WestConnex

New M5

Submissions and Preferred Infrastructure Report

Main Volume Chapters 1 to 4

Figure 4-1 Contour map for change in maximum 24-hour average PM_{2.5} (2031-DSC minus 2031-DM, 10m)

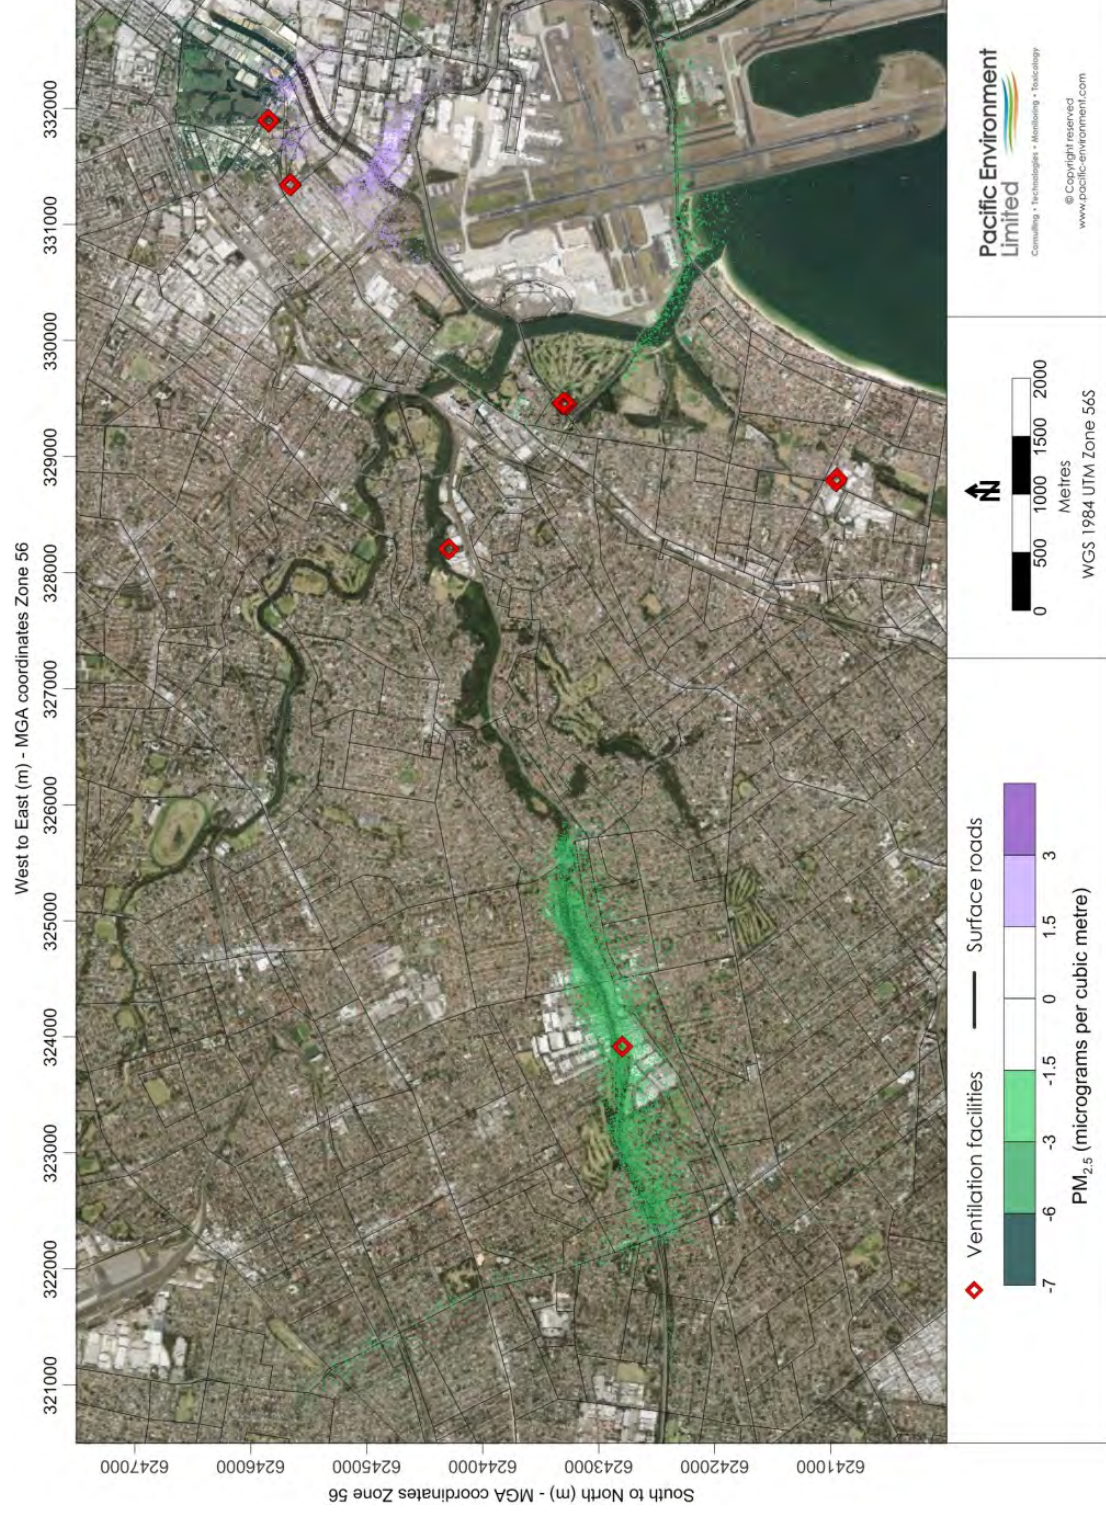
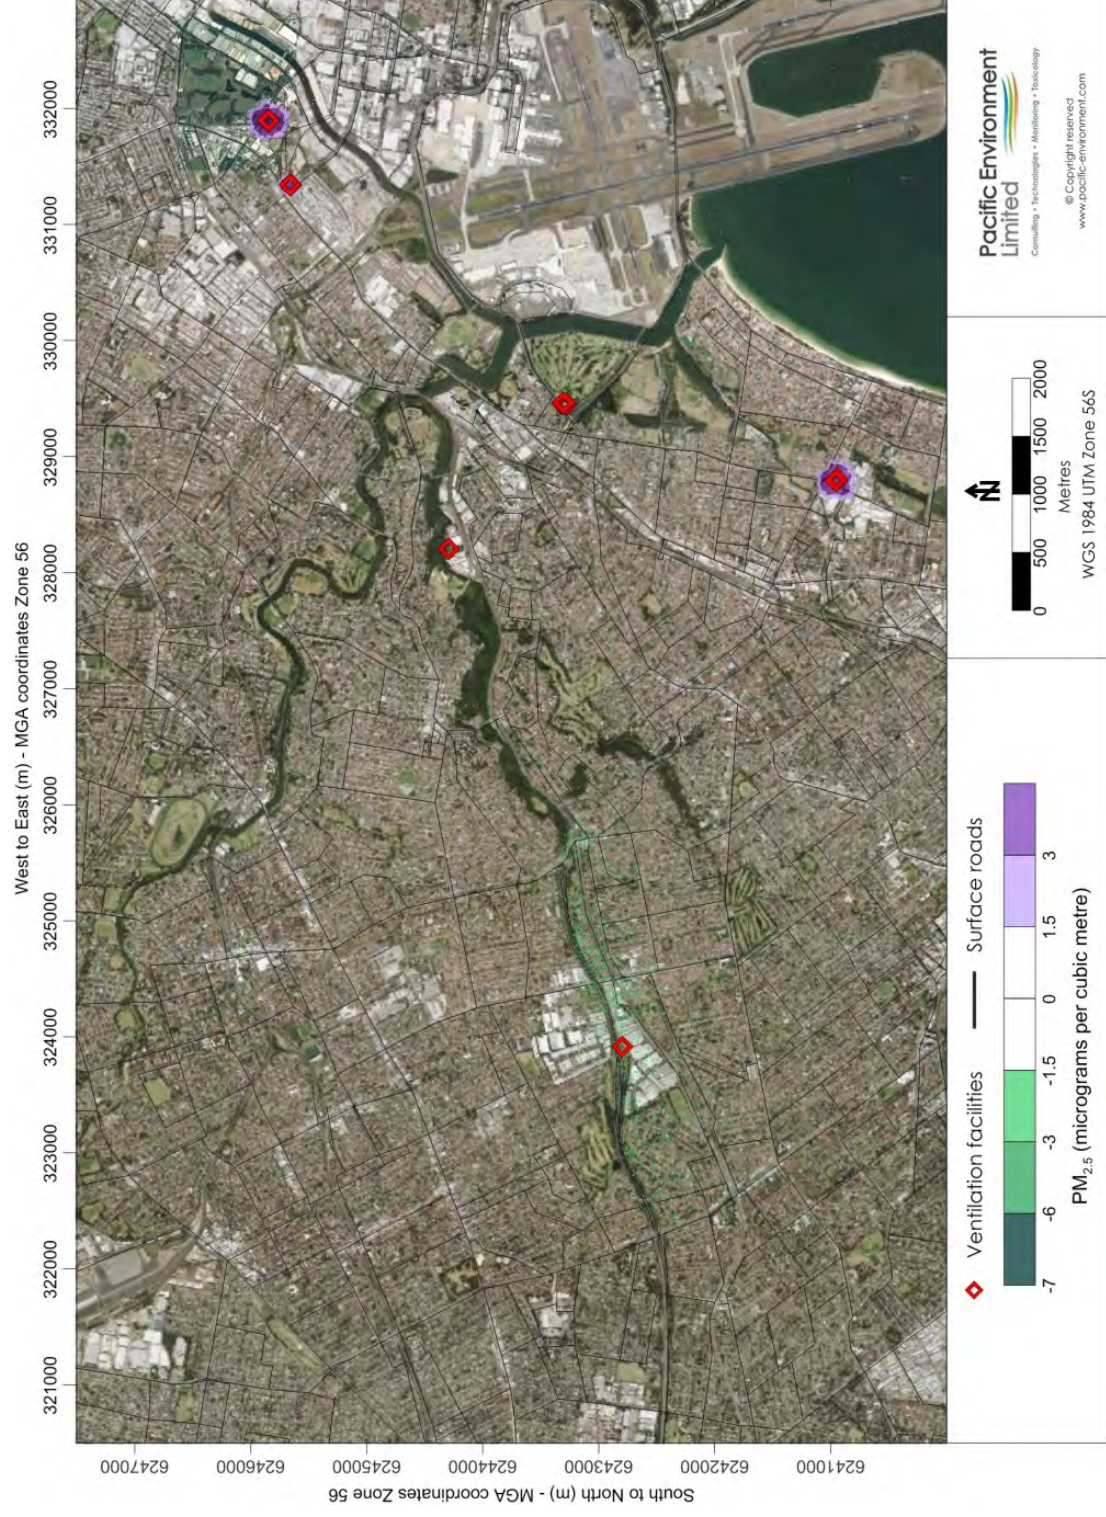
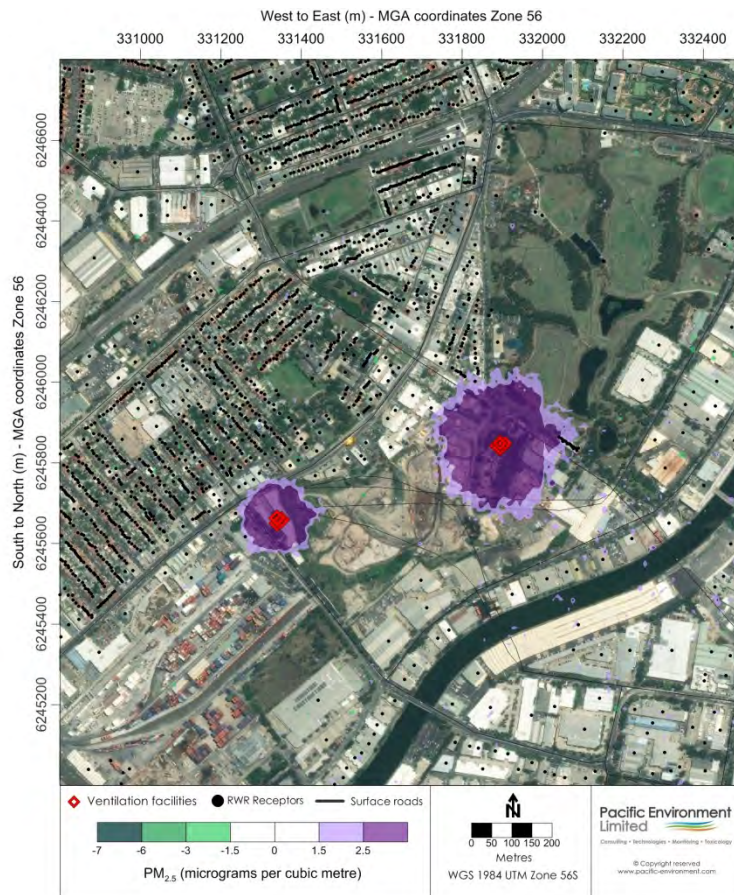
The phrase 'does not constitute a problem' is an odd one to use and seems to contradict the following statement. The results clearly show that there is strong potential for a problem were this outlet to be located near multi-storey buildings, or were such buildings to be proposed in the future. Furthermore 'immediate vicinity' is quite vague. A qualitative impression of what this means is given by Figure 9-101 but this contains neither any scale for distance, nor does the scale for $PM_{2.5}$ explicitly match the scale used in previous figures. We accept that the Southern extension is not being formally assessed in this EIS, but we consider this particular result to be important as even the EIS text indicates it may require careful management. This section of the assessment should be more specific.

Figure 4-1 and **Figure 4-2** present contour maps showing the changes in maximum 24-hour mean PM_{2.5} concentrations in the 2031-DSC scenario at heights of 10 metres and 30 metres respectively. These can be compared with the changes in ground-level concentrations for the same scenario (Figure K-167 in Appendix K of the EIS). **Figure 4-3** presents a contour map showing the changes in maximum 24-hour mean PM_{2.5} concentrations in the 2031-DSC scenario at a height of 30 metres in the vicinity of the St Peters interchange and M4-M5 Link ventilation facilities.

Figure 4-4 Geological cross section

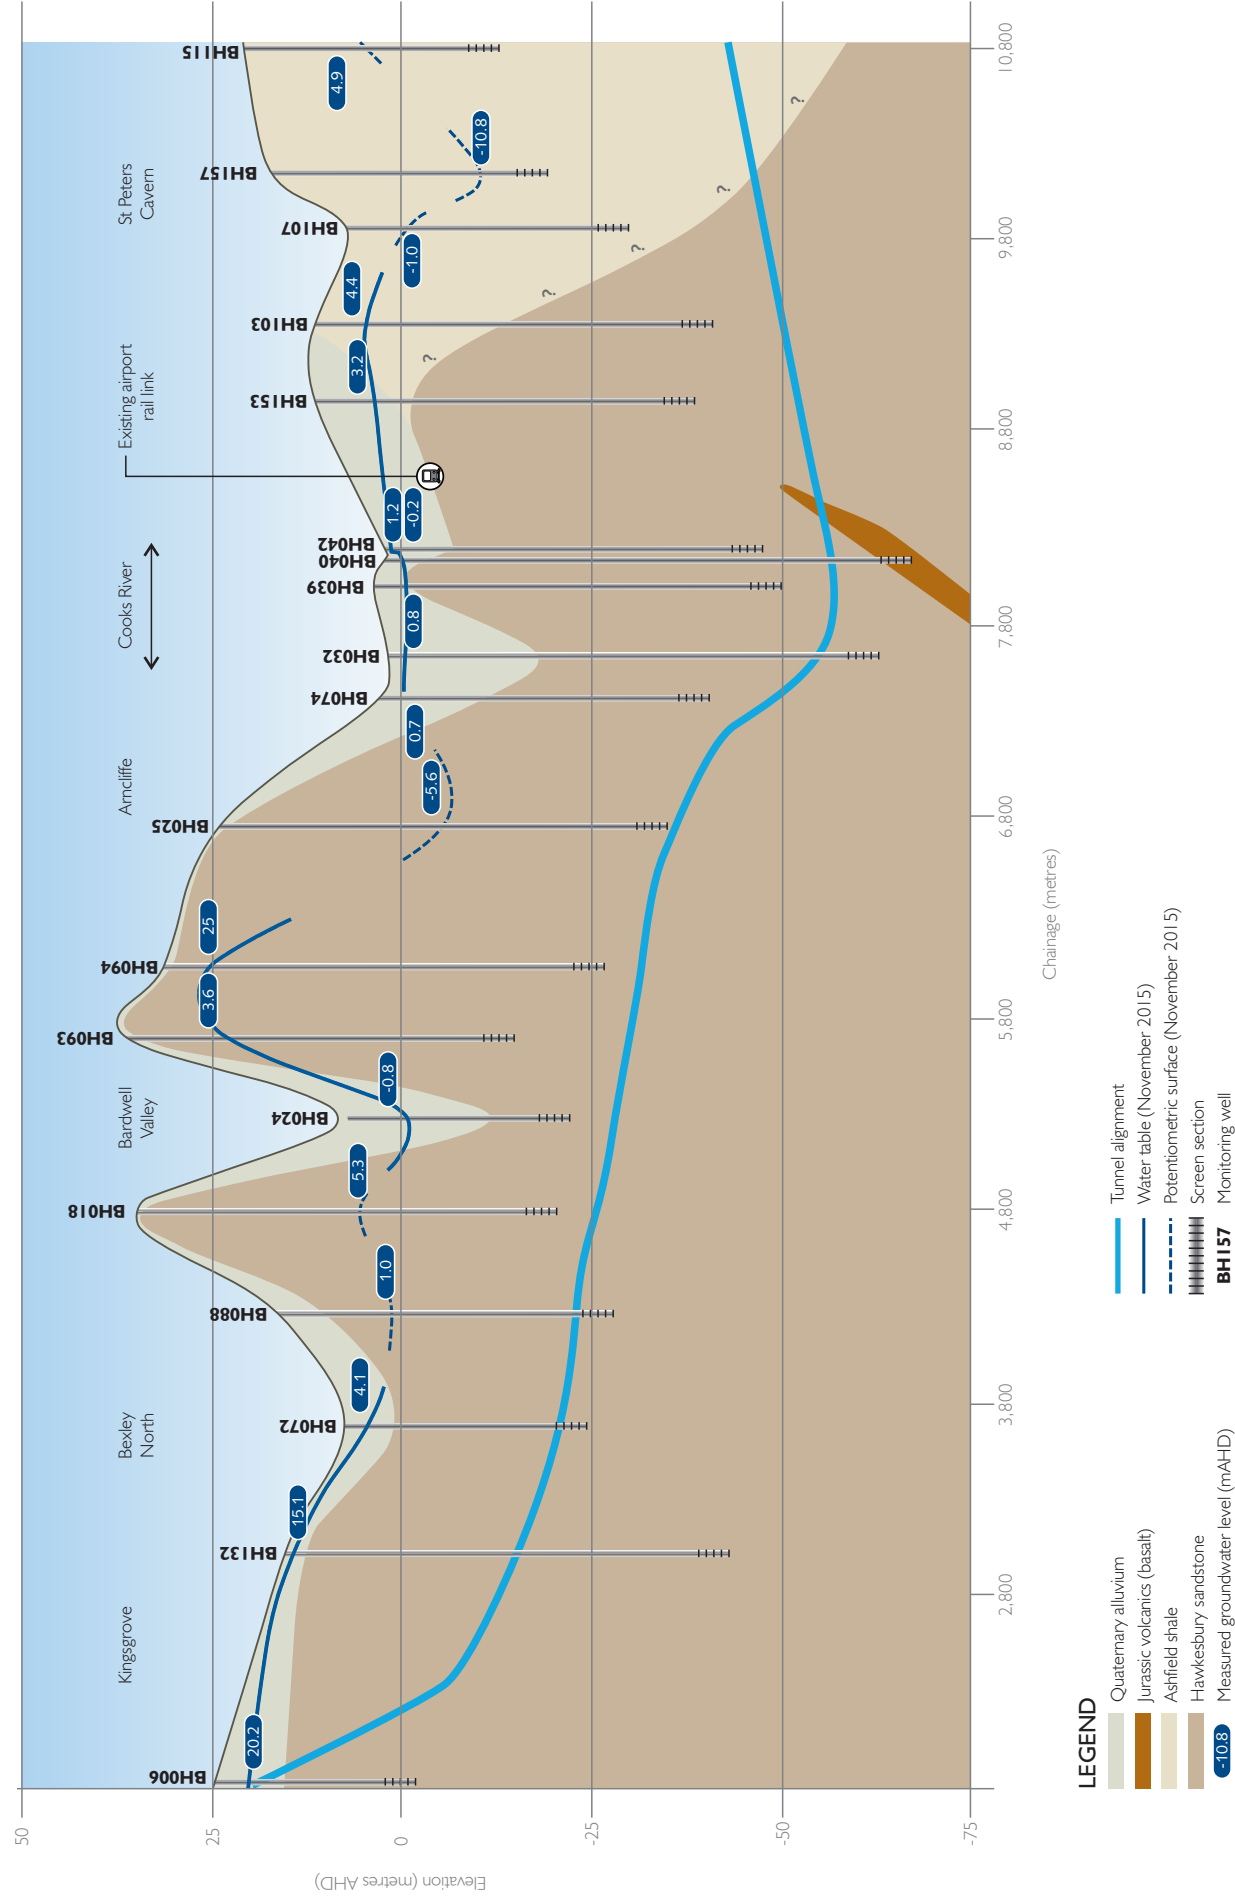
The model uses SWL data supplied for calibration purposes. These data e.g. as presented in Table 5-2 (Appendix A) and which are also represented in Figure 3-5 (p25, Appendix Q) are discussed previously. The data should be re-examined and any consequential amendments or adjustments made throughout the modelling report as necessary.

Note that Figure 3-5 in the Technical working paper: Groundwater representing a geological cross section has been amended (refer **Figure 4-4**). The representation of groundwater levels has been altered to reflect the water table in unconfined conditions and the potentiometric head in partially confined and confined conditions.

Note that Figure 3-5 in the Groundwater Technical Report representing a geological cross section has been amended (refer **Figure 4-4**). The representation of groundwater levels has been altered to reflect the water table in unconfined conditions and the potentiometric head in partially confined and confined conditions.

Figure 4-7 Effect of updating data for New M5 in the relationships between 'contemporaneous' and 'statistical' concentrations

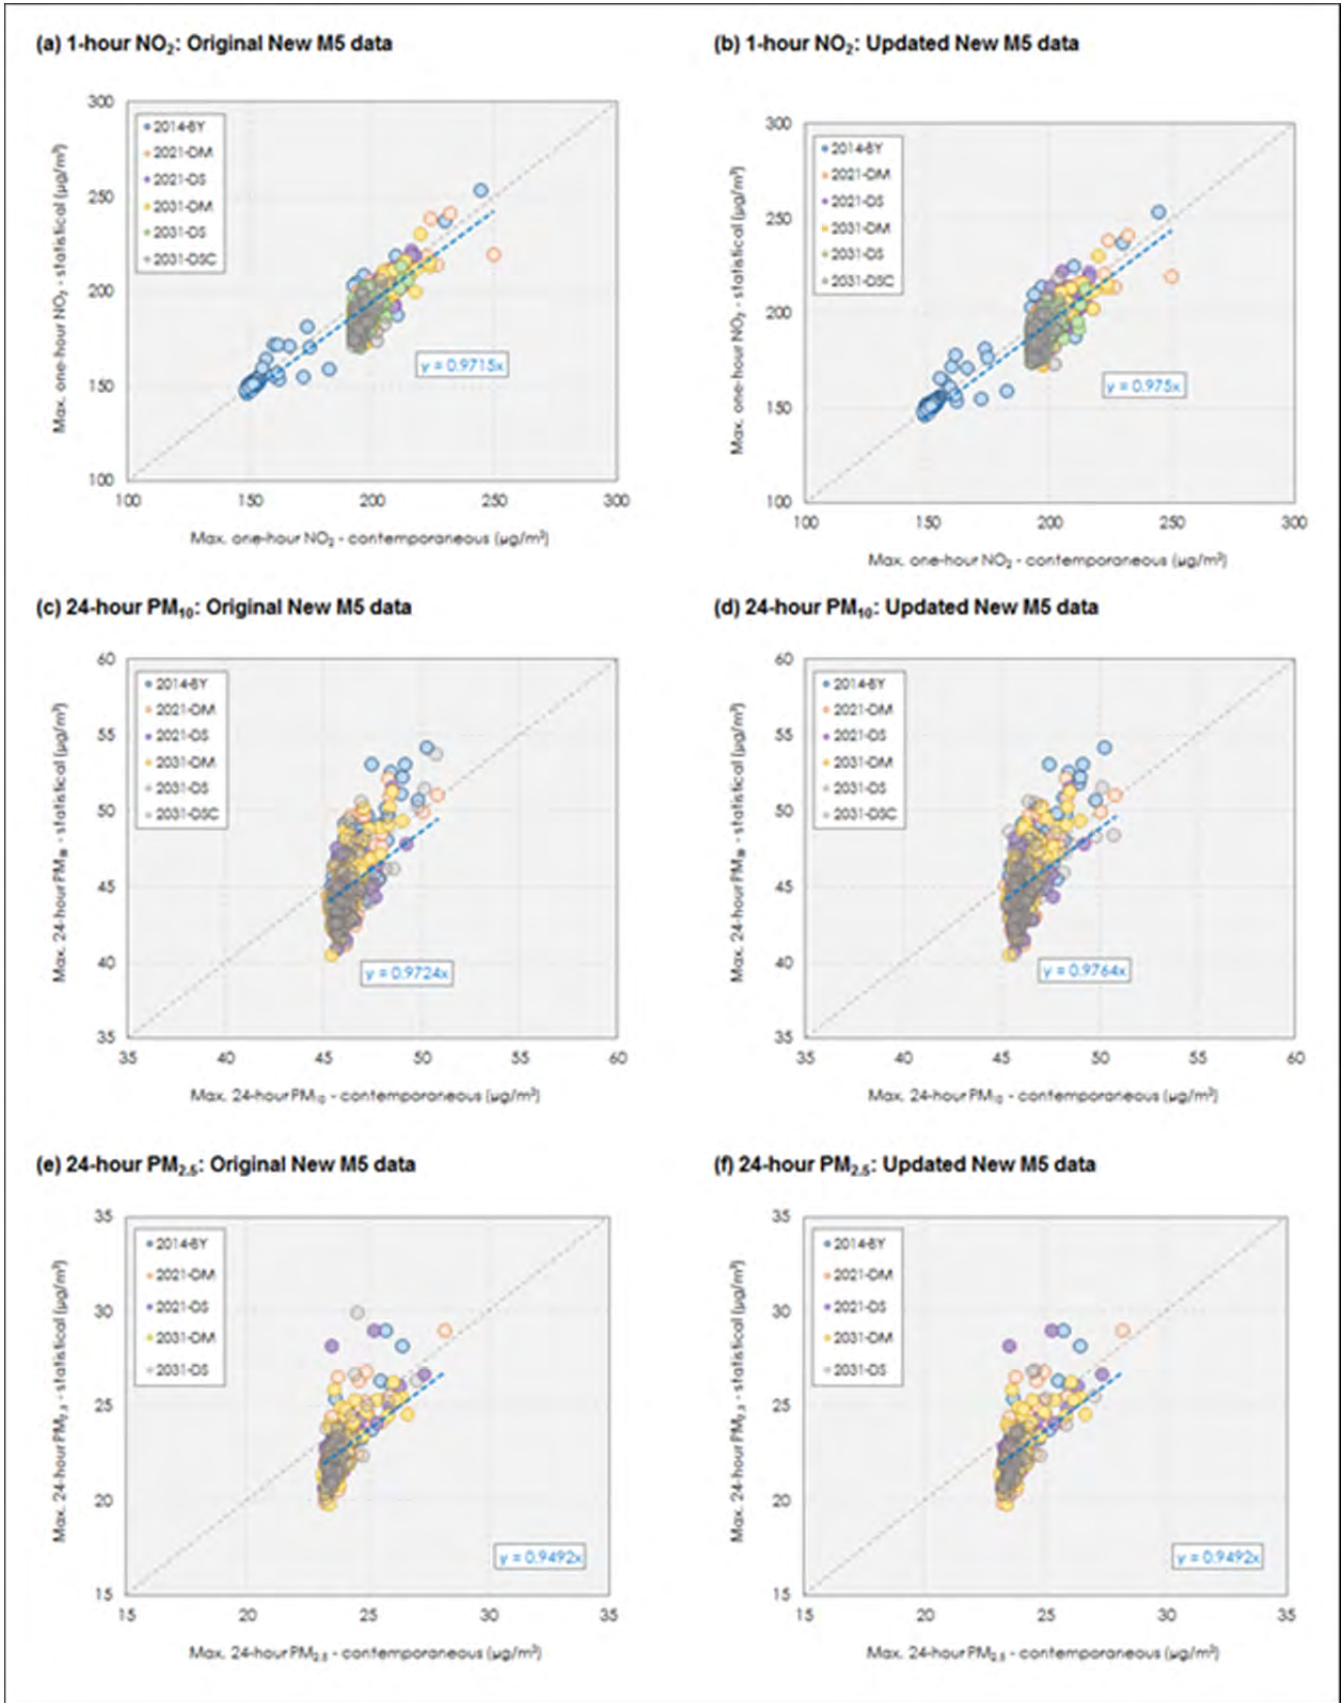
Background NO_x and NO_2 concentrations are important factors to determine the conversion of NO_x to NO_2 . The comparison between the statistical and contemporaneous approach to evaluate the use of 98th percentile background in the statistical method shown in Figure 9-19 is exactly the same as for the M4 East project. The predicted impacts should be project specific and therefore it is expected that the results for M4 East and the New M5 would look different.

It is also noted that the statistical and contemporaneous comparison for 24-hour average PM_{10} (Figure 9-20) and 24-hour average $\text{PM}_{2.5}$ (Figure 9-21) are also exactly the same as the ones presented for the M4 East.

The figures were unable to be updated before the publication of the EIS. For the New M5 assessment the synthetic background profiles for NO_x and PM_{10} were modified compared with the M4 East assessment, meaning that the 98th percentile background concentrations used in the assessment were not reflected in the original EIS figures. In addition, the original figures contained GRAL predictions for the New M5 which were different from those in the final assessment. The figures have therefore been updated to reflect these changes, and the plots with the original and updated data for the New M5 are shown in **Figure 4-7**. It can be seen that updating the New M5 data had very little effect on the relationships between the contemporaneous and statistical concentrations. It should be noted that the actual air quality assessment for the New M5 was not affected by this change, as the correct values were used for the synthetic background profile and the GRAL predictions.
